Subject: **COLUMBIA GENERATING STATION, DOCKET NO. 50-397
RESPONSE TO REQUEST FOR ADDITIONAL INFORMATION
RELATED TO GENERIC LETTER 2006-02 RESPONSE**

**RESPONSE TO REQUEST FOR ADDITIONAL INFORMATION RELATED TO
GENERIC LETTER 2006-02 RESPONSE**

RESPONSE TO REQUEST FOR ADDITIONAL INFORMATION

Figure 1. Major Northwest Hydroelectric Stations

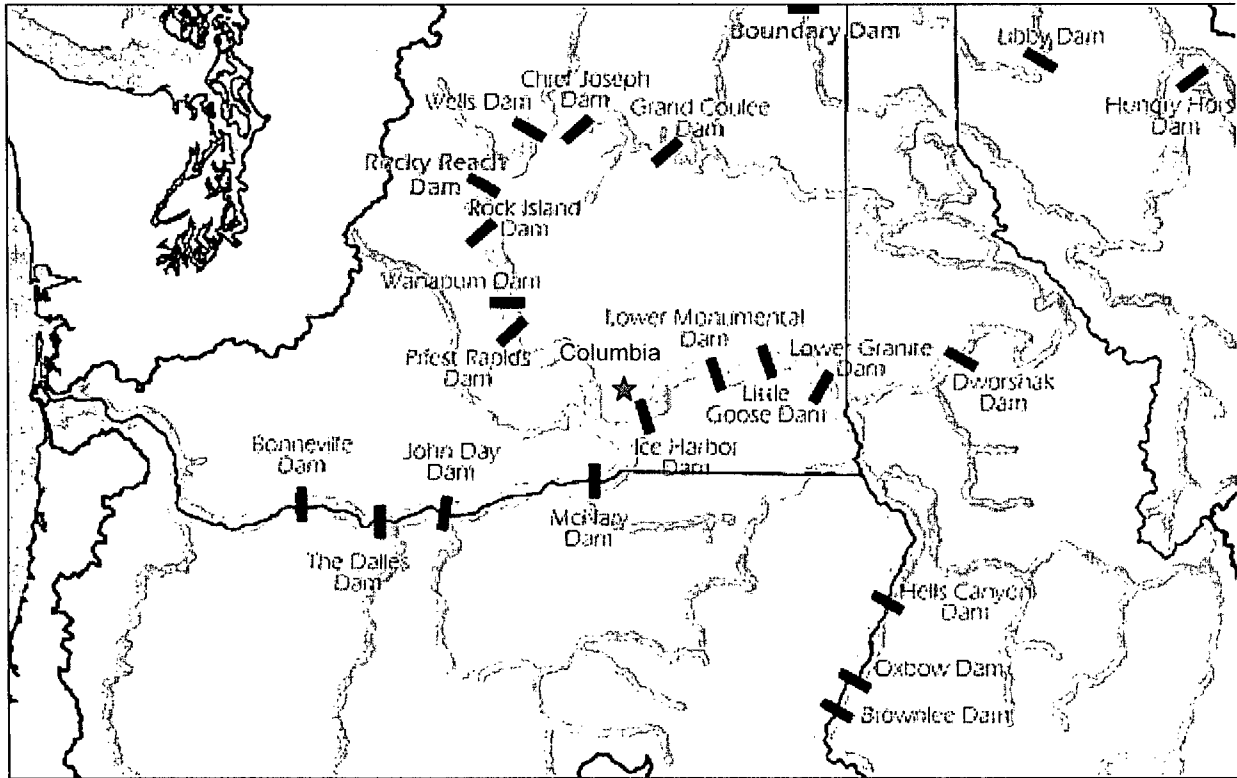
Certain regions during certain times of the year (seasonal variations) experience higher grid stress as is indicated in Electric Power Research Institute (EPRI) Report 1011759, Table 4-7, Grid LOOP Adjustment Factor, and NRC NUREG/CR-6890. Do you adjust the base LOOP frequency in your probabilistic risk assessment (PRA) and Maintenance Rule evaluations for various seasons? If you do not consider seasonal variations in base LOOP frequency in your PRA and Maintenance Rule evaluations, explain why it is acceptable not to do so.

- 1) Table 4-7 of EPRI-1011759 is not a fully realistic representation of Columbia-specific grid conditions. For example, the table estimates the spring season Grid-LOOP Adjustment Factor to be H (High) for the WSCC (Western System Coordinating Council) Region, but for Columbia, the BPA hydroelectric units (Figure 1) typically experience high runoff during spring

and produce abundant power, to the degree that in some years BPA has requested an economic dispatch of Columbia operation during the spring. As a result, the grid is less stressed and more stable during the spring season.
